FARRAGUT VISUAL RESOURCES REVIEW BOARD

MEMORANDUM

TO: Farragut Visual Resources Review Board
FROM: Bart Hose, Assistant Community Development Director
SUBJECT: Regularly Scheduled Meeting - Tuesday, January 22, 2019 at 7:00 p.m.

L1.01 - ENLARGED
LANDSCAPE PLAN

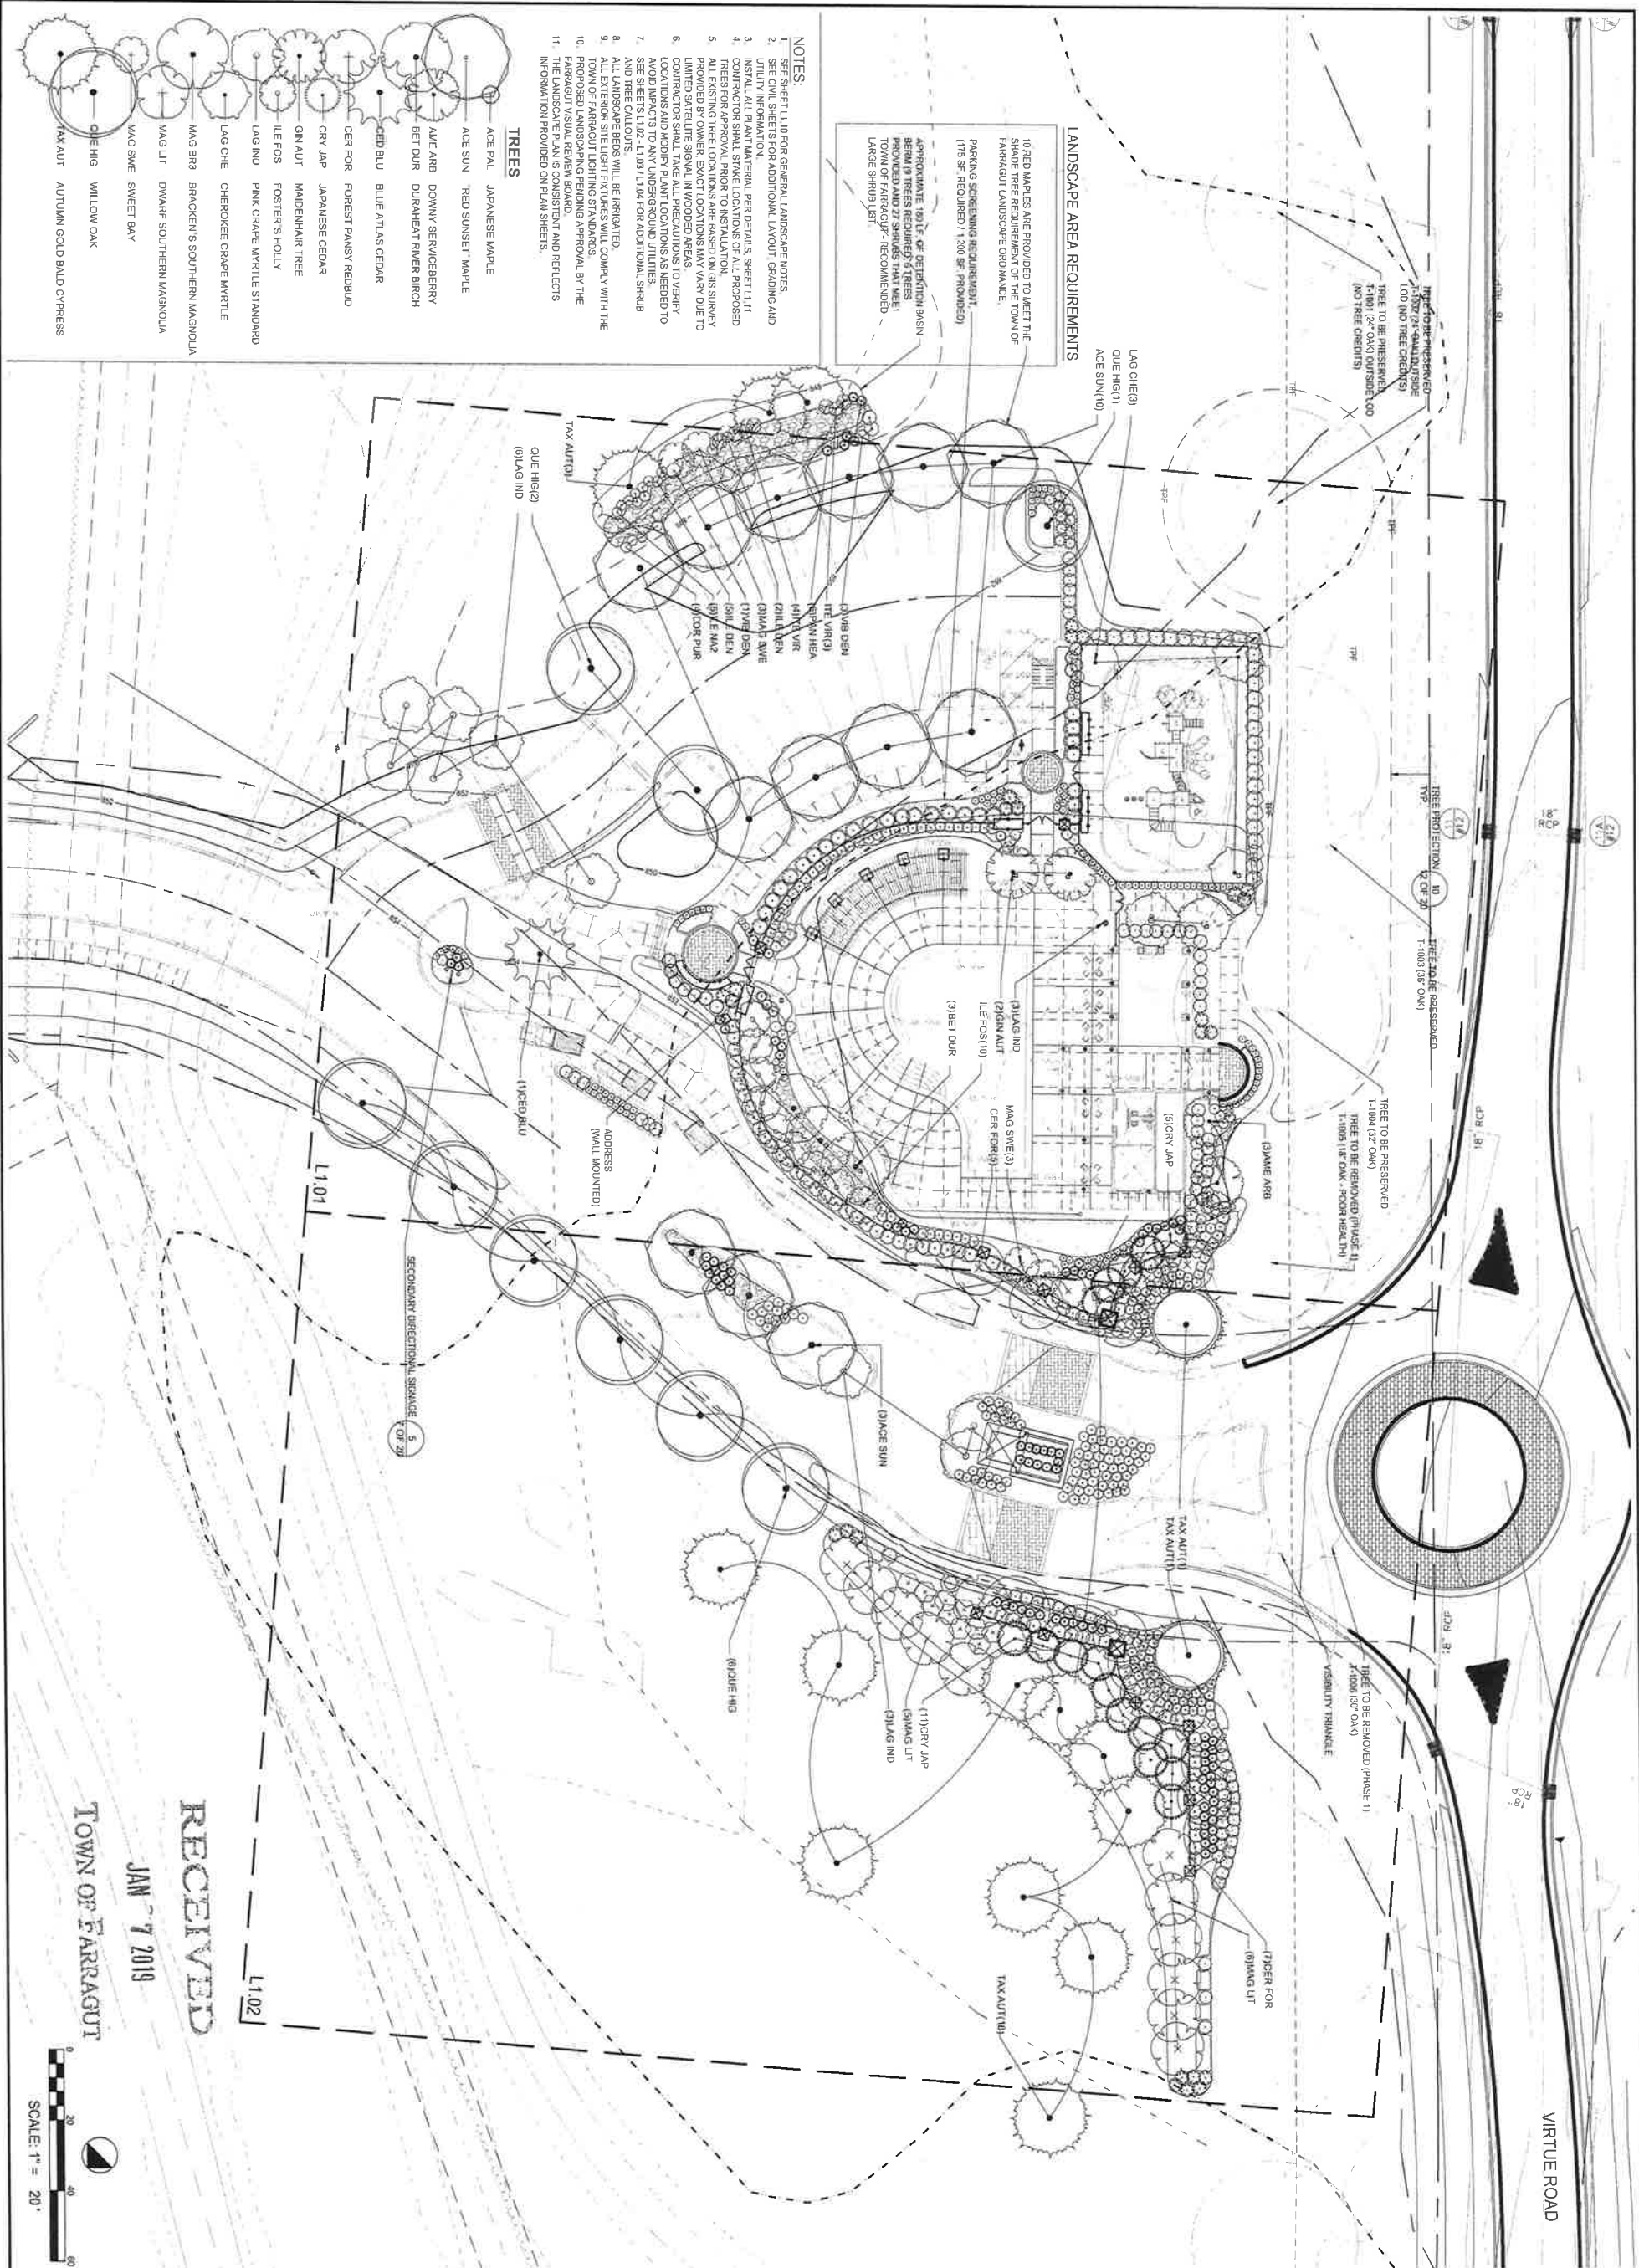
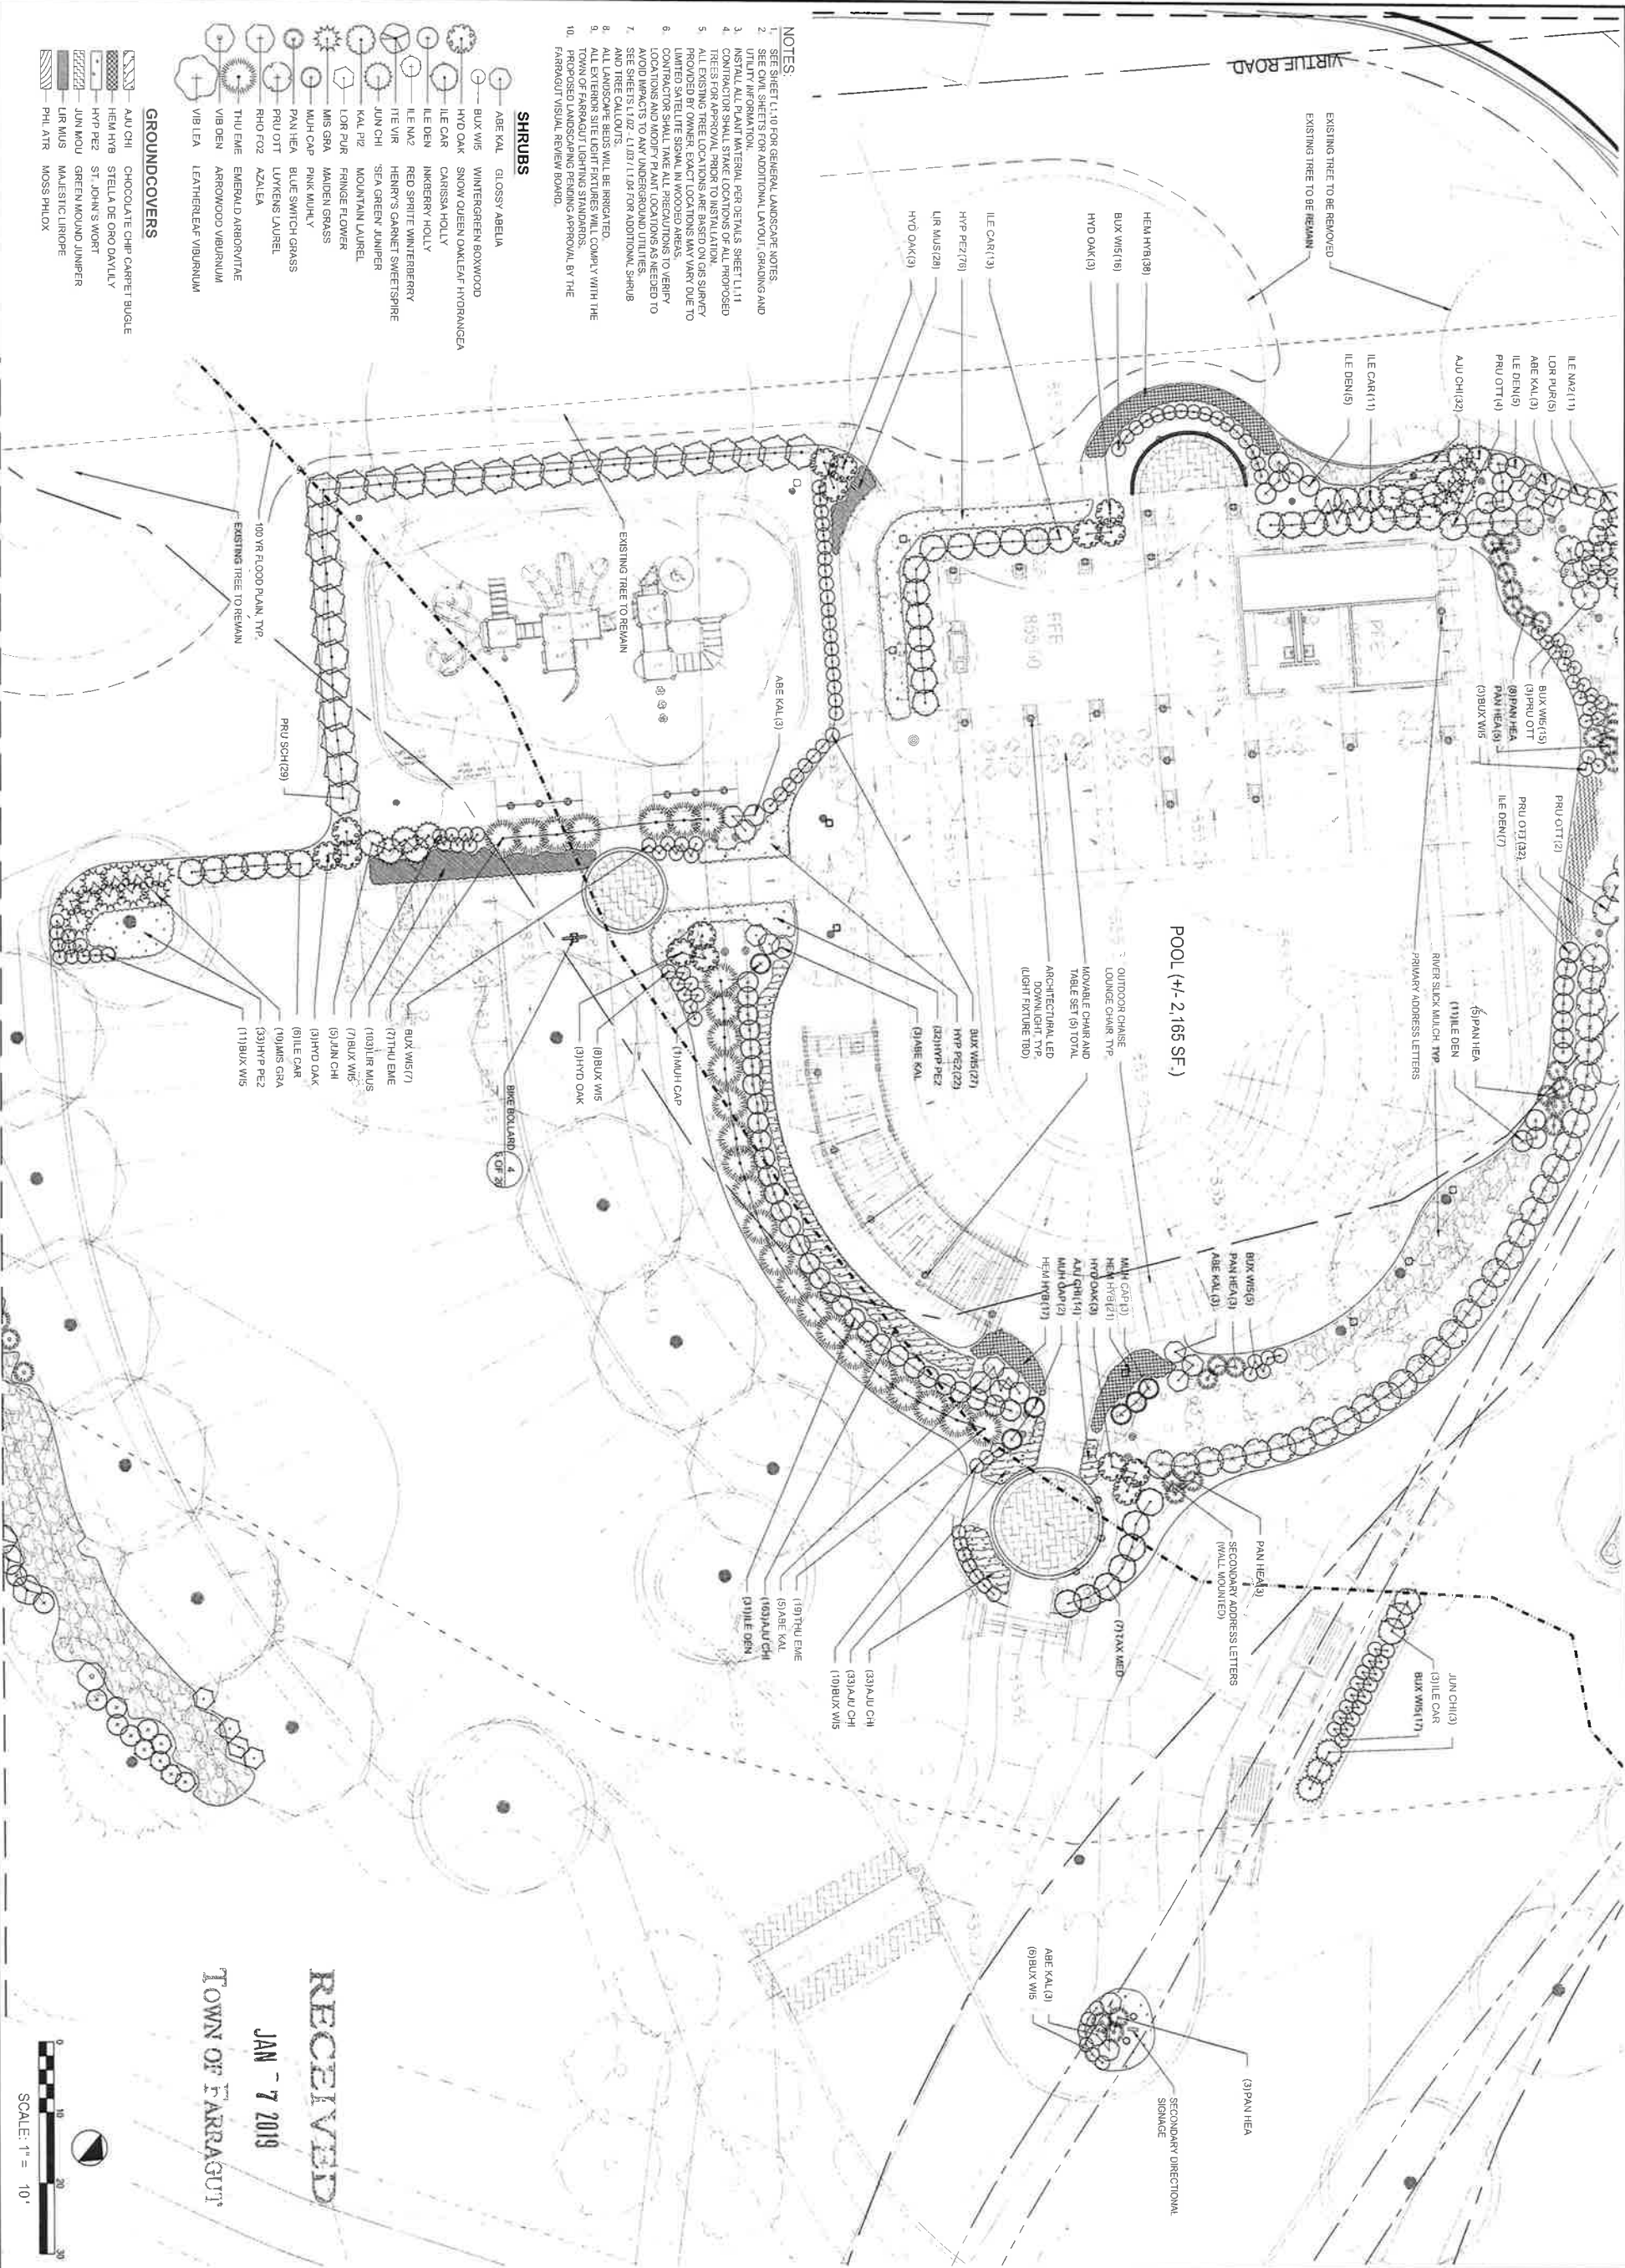
This item involves a landscaping plan for the planned clubhouse and entrance area at Brookmere Subdivision, a large new subdivision being developed off Virtue Road. The landscape plan includes the clubhouse and subdivision entrance area, including the permanent entrance sign. The plan depicts extensive landscaping for the areas in question.

Staff recommends approval of the plan subject to listing all plant material sizes in accordance with the Town's landscaping requirements on the included plant schedule (sheet 11 of 20).
